Access Compliance Report

Public Rights-of-Way

Intersection ID: N/A	Main Street: AGNEW_DR	Cross Street: PAMPLIN_CT	Location: NW
ADA ID: 6DA83F22B21C	Ramp Type: Perp	Initial Pass/Fail: Fail	Overall Compliance: No
		Severity Score: 10

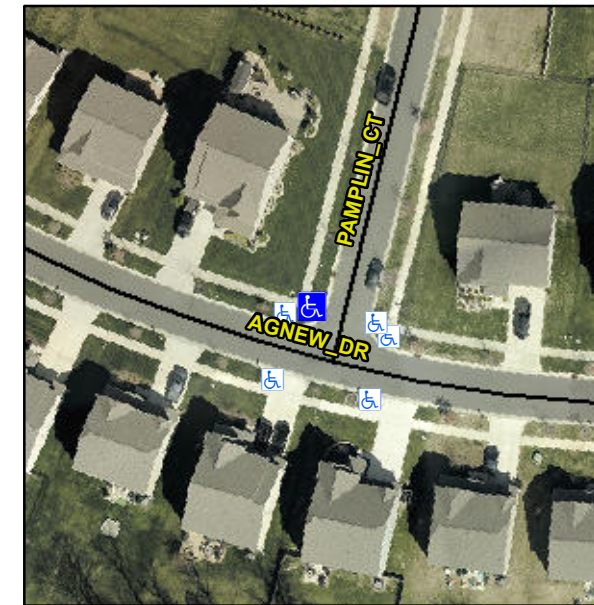
Not Found, R304.5.1, R304.5.3

Compliance	Description	Data	Compliance	Description	Data
N/A	Ramp Length (in)	102.0	Yes	Ramp Slope (%)	6.6
No	Ramp Width (in)	47.0	No	Ramp XSlope (%)	2.2
N/A	Flare Type LT	N/A	N/A	Flare Type RT	N/A
N/A	Flare Slope LT (%)	N/A	N/A	Flare Slope RT (%)	N/A
N/A	Flare Traversable LT?	N/A	N/A	Flare Traversable RT?	N/A
N/A	Landing Length (in)	N/A	N/A	DWS Provided?	N/A
N/A	Landing Width (in)	N/A	N/A	DWS Contrast?	N/A
N/A	Landing Slope (%)	N/A	N/A	DWS Length (in)	N/A
N/A	Landing X Slope (%)	N/A	N/A	DWS Full Width?	N/A
N/A	Landing Curb? (Y/N)	N/A	N/A	DWS Offset (in)	N/A
N/A	Shared Landing?	N/A			
N/A	Gutter Ponding?	N/A	N/A	Gutter Slope (%)	N/A
N/A	Gutter Lip Ht (in)	N/A	N/A	Gutter X Slope (%)	N/A
N/A	Painted X Walk1?	No	N/A	Painted X Walk2?	N/A
	X Walk 1 Direction	To SE		X Walk 2 Direction	N/A
N/A	X Walk 1 Width (in)	N/A	N/A	X Walk 2 Width (in)	N/A
	X Walk 1 Slope (%)	2.6		X Walk 2 Slope (%)	N/A
	X Walk 1 X Slope (%)	2.4		X Walk 2 X Slope (%)	N/A

Remove & Replace Entire Ramp.
